Relevant Information for Local Planning Panel

SUBJECT: Information Relevant To Item 3 – Development Application: 21C Billyard Avenue, Elizabeth Bay – D/2023/727

**SUPPLEMENTARY JOINT EXPERT REPORT ADDRESSING HEIGHT OF BUILDINGS
CALCULATION**

Supplementary Joint Expert Report
Appendix B: Height Plane Amendment

Survey - West Boundary

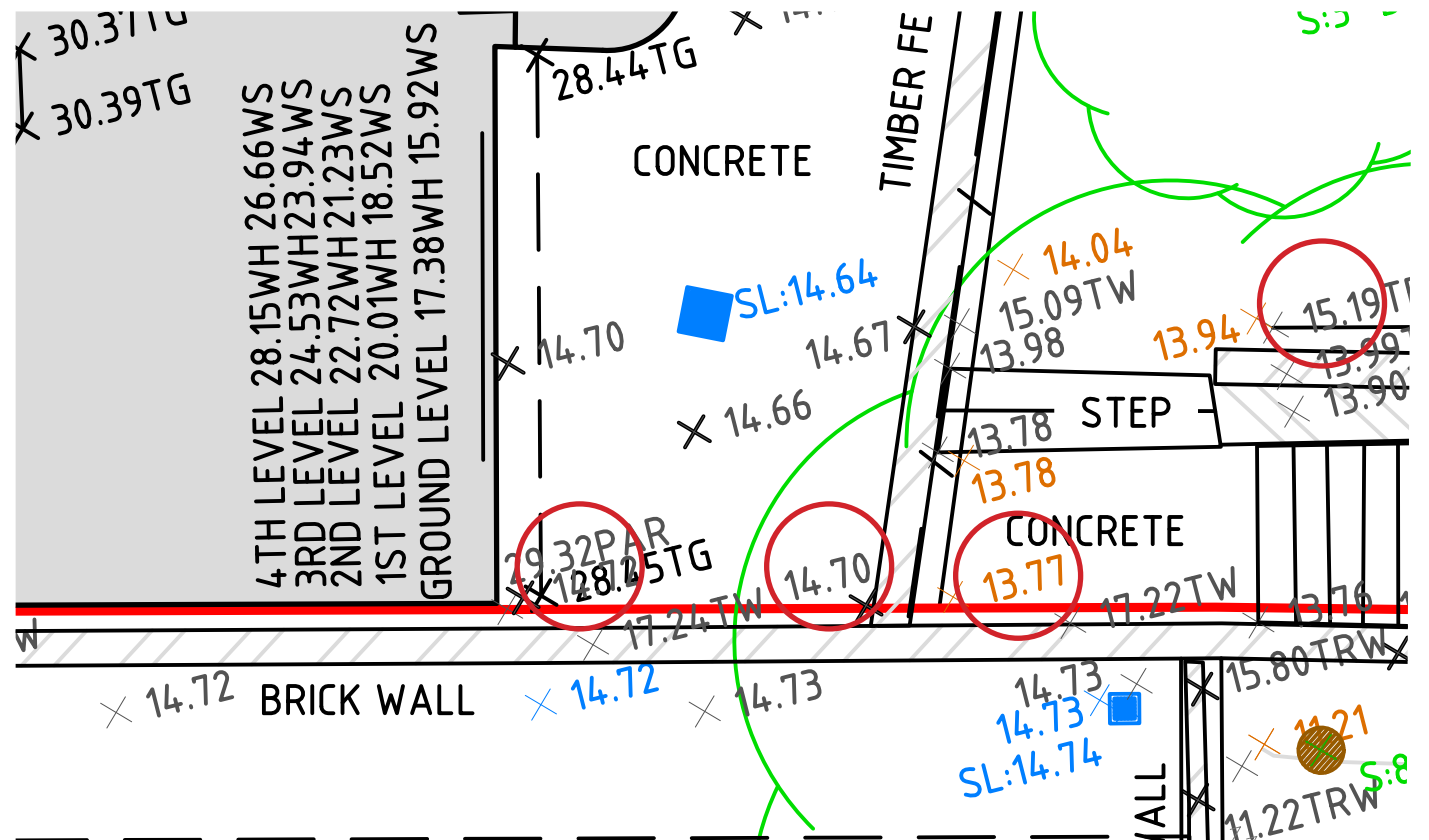
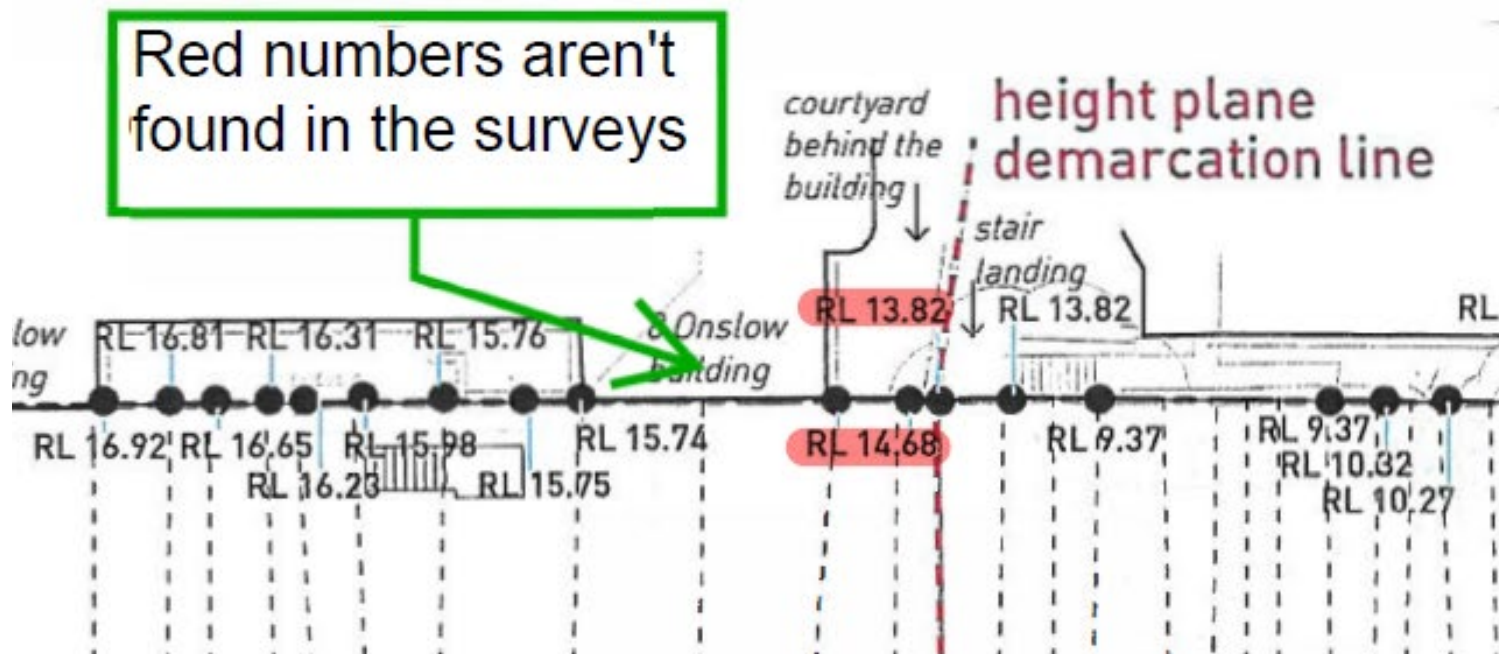
Minor differences between the survey and height plane extrapolation related to differences between the 2D survey and the 3D model.

These differences are extremely minor (between 2cm and 4cm) and do not have any impact on the height plane.

Survey - East Boundary

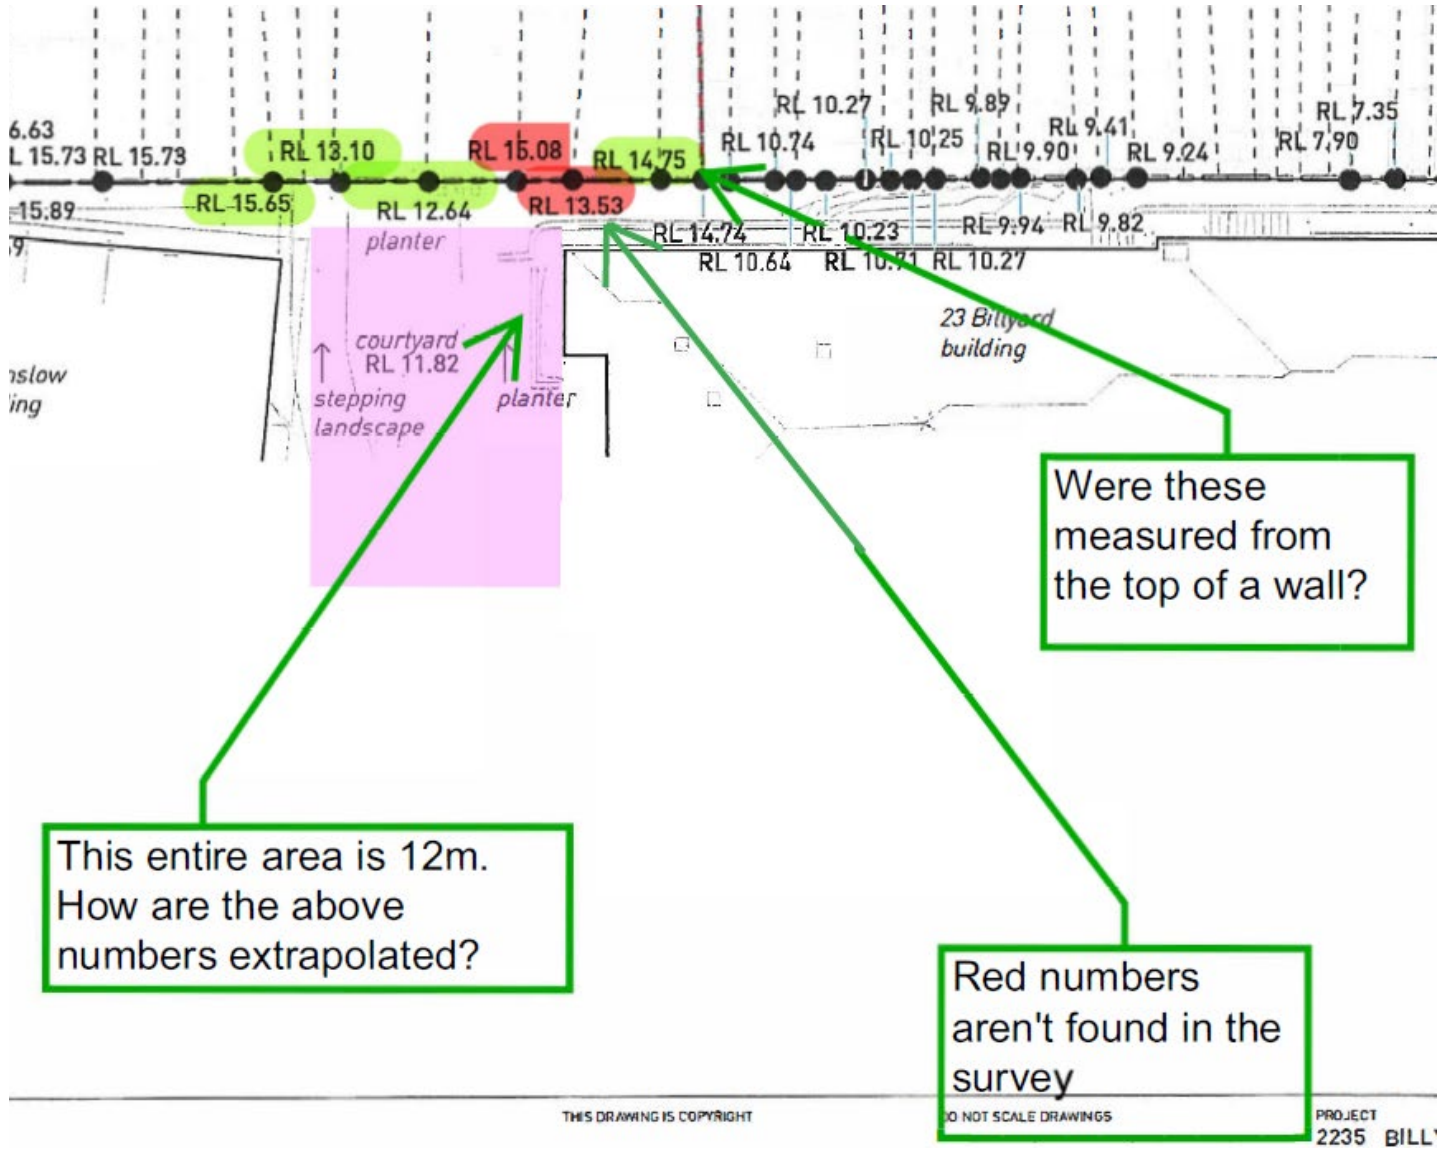
There was an error in two survey points being RL15.08m and RL13.53m, highlighted in red in the Submission.

These points were part of the survey data used to develop and extrapolate the 3D height plane. This was from additional survey information later requested by Council during the Without Prejudice conferencing.

In the updated 2D survey (Ref F dated 05.07.24), these two survey points (RL15.08m and RL13.53m) were deleted, and a new point RL11.82m was added.

This correction to the survey was not clouded nor communicated to the project team and consequently not updated in the 3D height plane extrapolation currently before the Court.

The surveyor has confirmed that those two points were originally incorrectly surveyed and were identified as such when they returned to provide further survey data in July 2024. This is why they were deleted from the survey and a new point added.

Survey - East Boundary

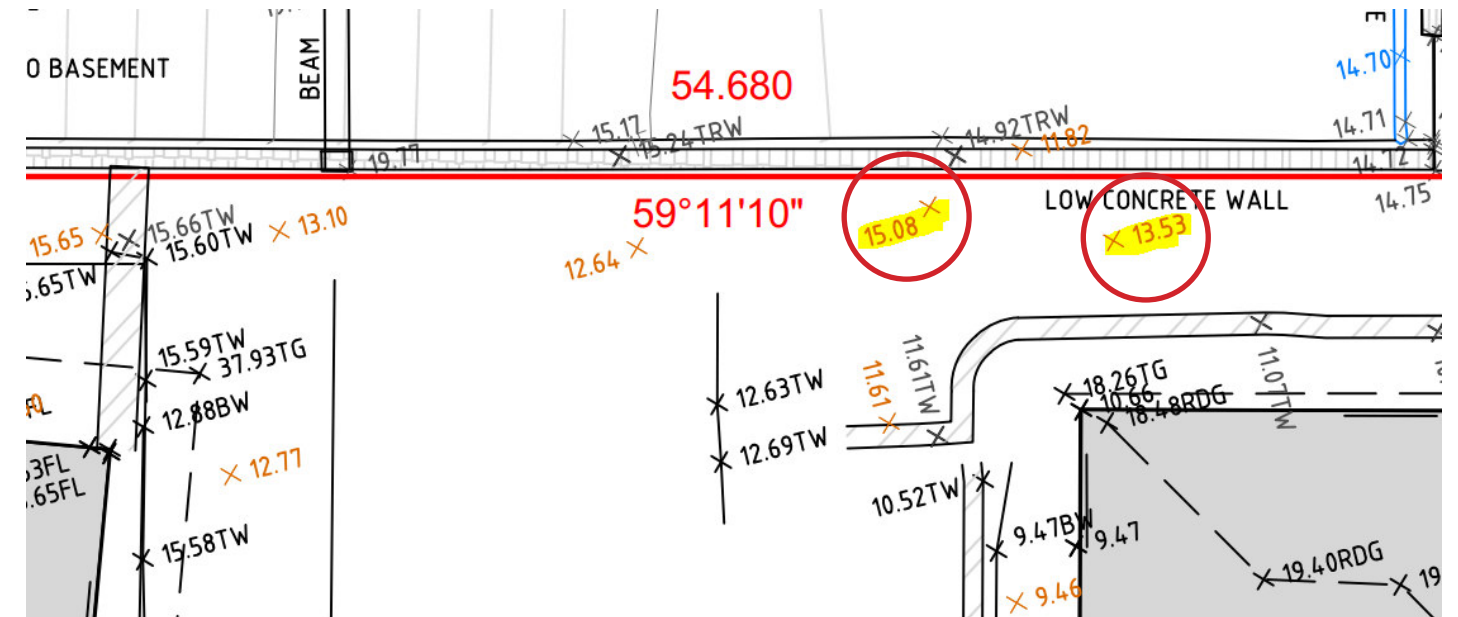
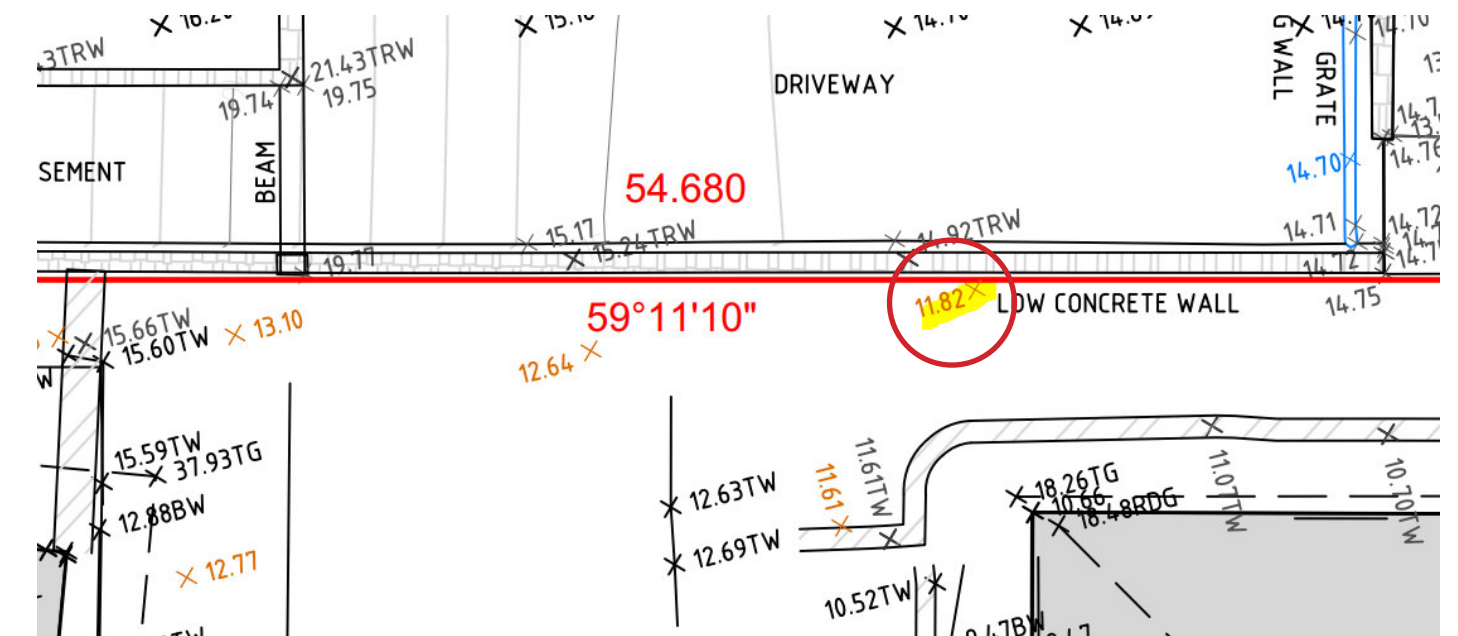
Excerpt from Survey Rev D dated 05.03.24

Excerpt from Survey Rev F dated 05.07.24
